**Addendum No. 1**

RE: Contract # C204069

**Wake County (I-5506)**

I-40 and SR-1002 (Aviation Parkway) Interchange

TIP NO. I-5506	SHEET NO. SIGN-1
APPROVED: <i>Michael T. Rzepka</i>	
DATE: 1/25/2018

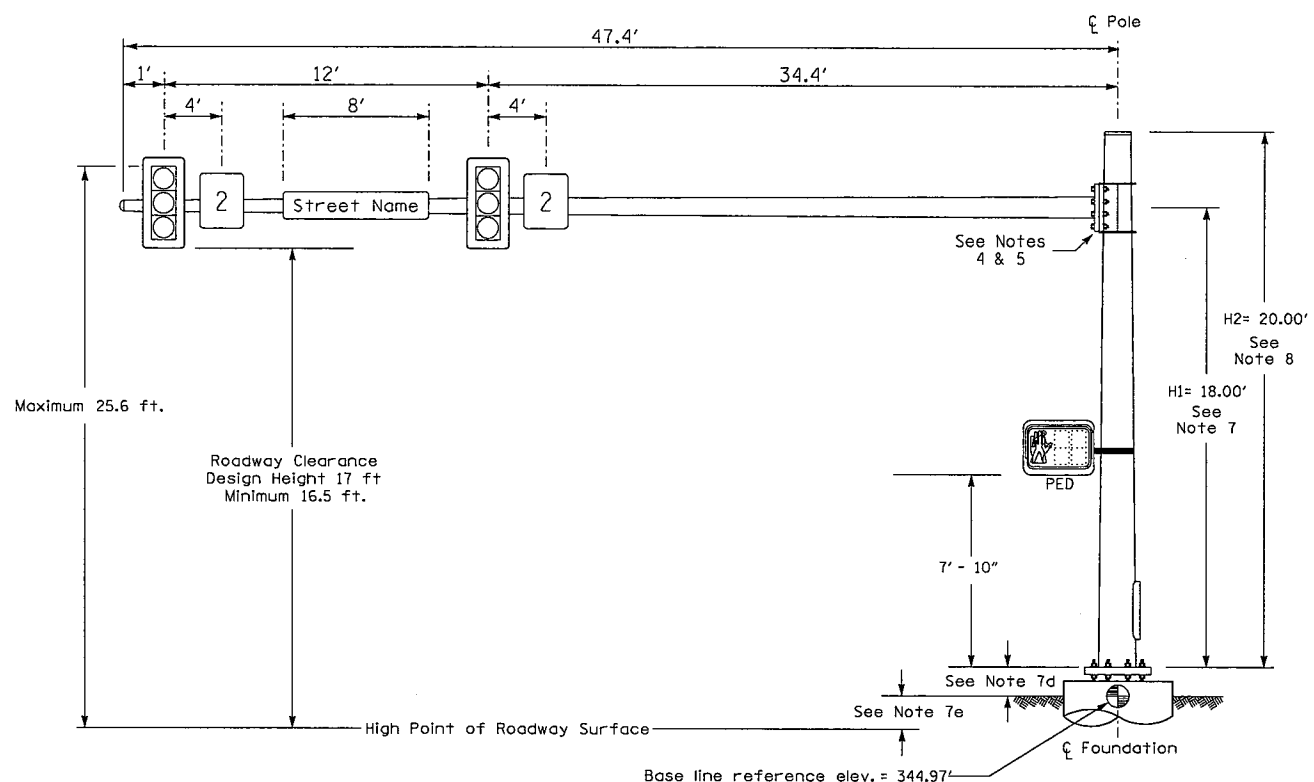
Sheet No.	Revisions
SIGN-1	Revised the Summary of Quantities to reflect the below noted quantity changes
SIG-11.3 and SIG-11.4	New Sheets to provide the loading diagram for "Metal Pole No. 5 and 6"
SIG-16.2 and SIG-16.3	New Sheet to provide the loading diagram for "Metal Pole No. 7 and 8 and Metal Pole No. 9"

Please void sheet No. SIGN-1 in your plans and staple the revised sheet thereto. Please staple new sheet Nos. SIG-11.3 and SIG-11.4 after existing Sheet No. SIG-11.2 and New Sheet Nos. SIG-16.2 and SIG-16.3 after existing Sheet No. SIG-16.1
